IB/OB JTAG Puzzle

- ▷ All SWBs from W31-OB2 have been removed today (manual de-soldering)

Pads on Module after removal

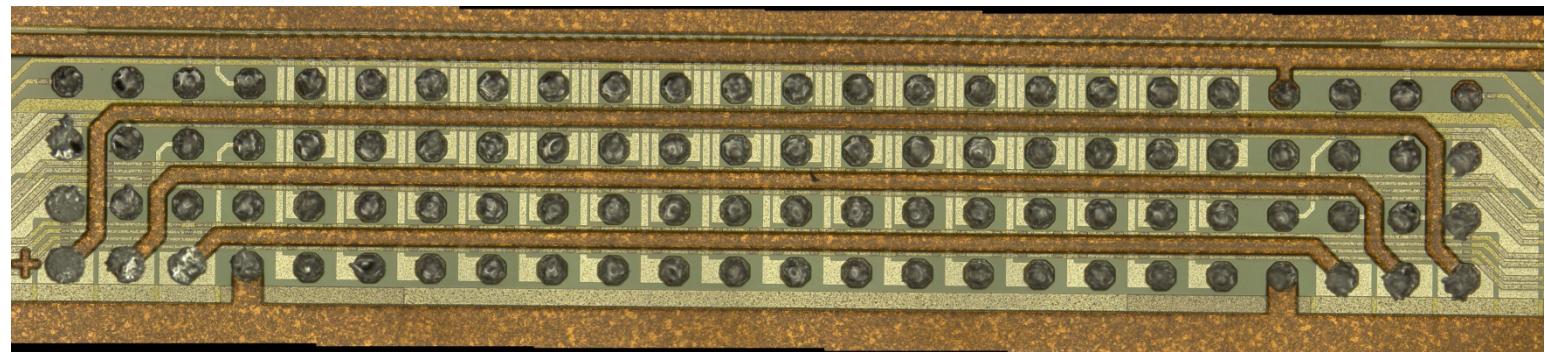
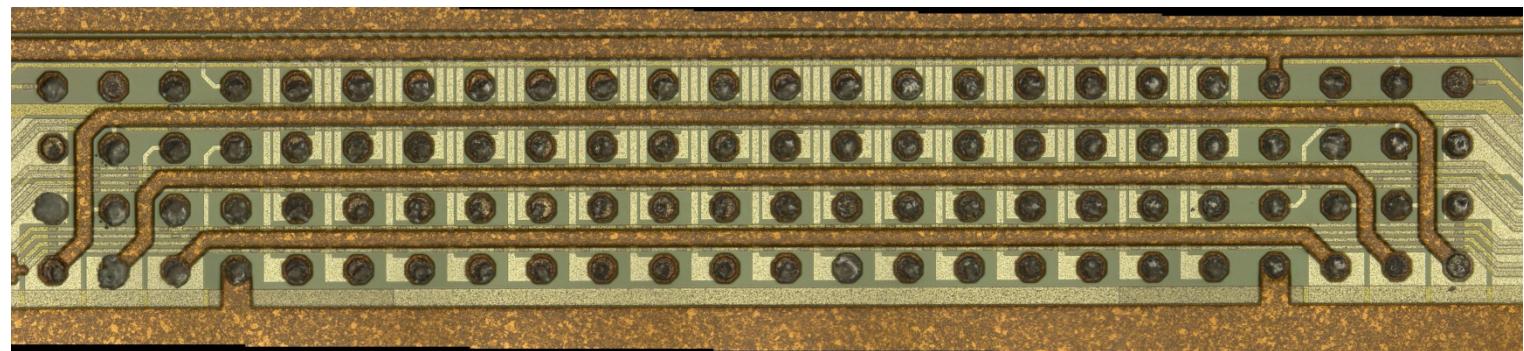
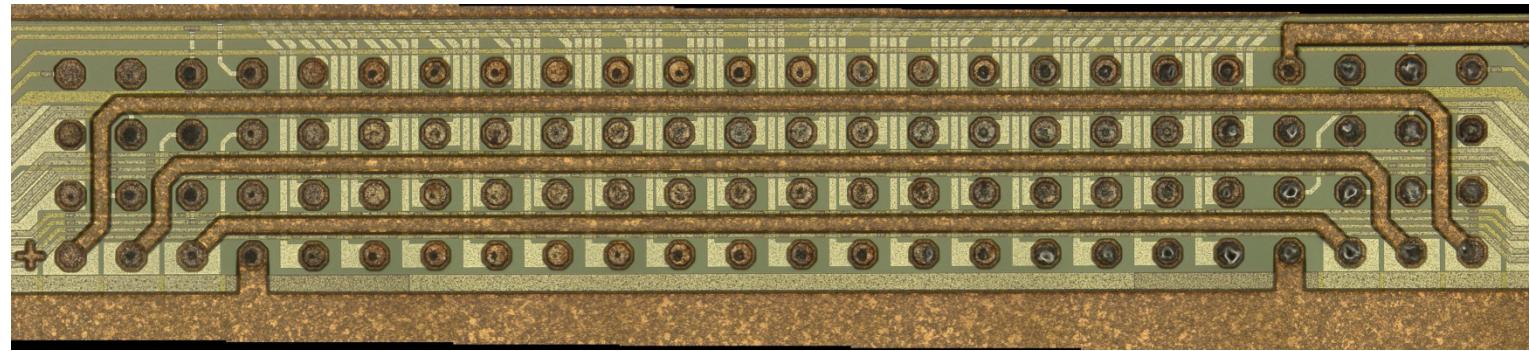
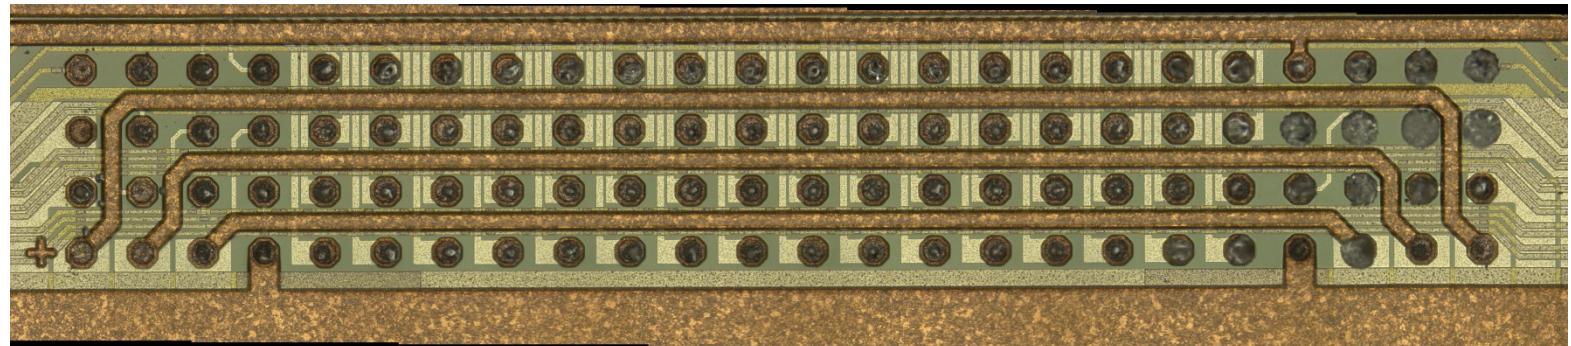
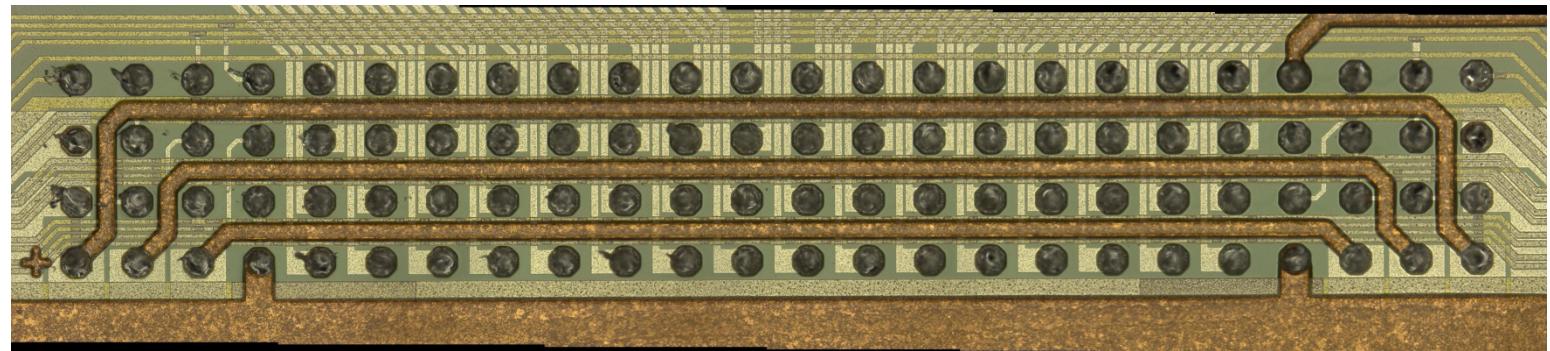
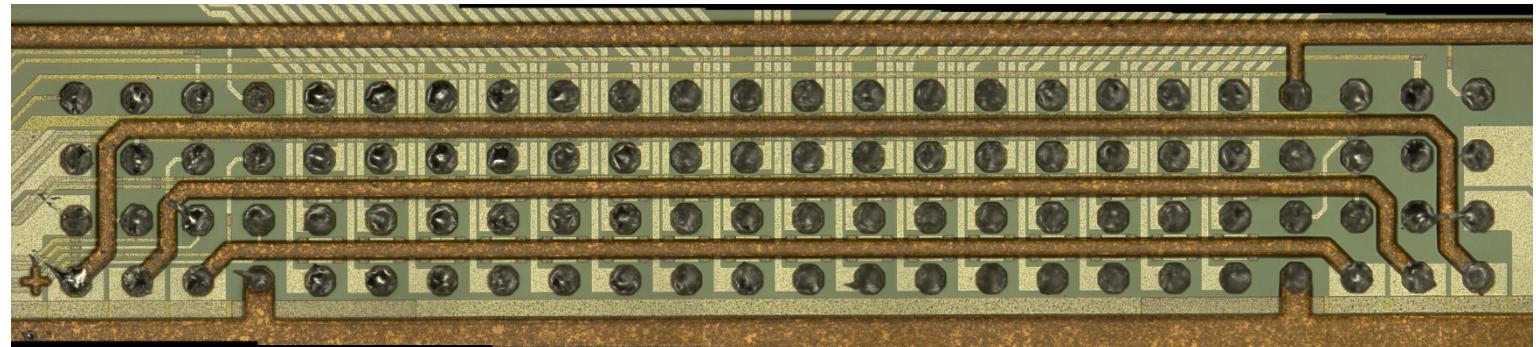
- ▷ Going from SWB1 → SWB6 wetting gets worse towards SWB3 and 4, then better towards SWB5 and 6
- ▷ Possible reasons
 - ↳ Reflow temperature not reached in the middle of the module due bad contact to the heat plate
 - ↳ talk to IZM....
 - ↳ In this case a second (local) reflow with HCOOH or flux might help
 - ↳ BCB (final passivation, solder stop) residues on the pads
 - ↳ Inhomogeneous „descum“ (plasma process is worse at bottom and at the edge of the wafer..)
 - ↳ Needs cross check,
 - ↳ possibly more descum, currently we remove 300-400 nm of BCB after final passivation
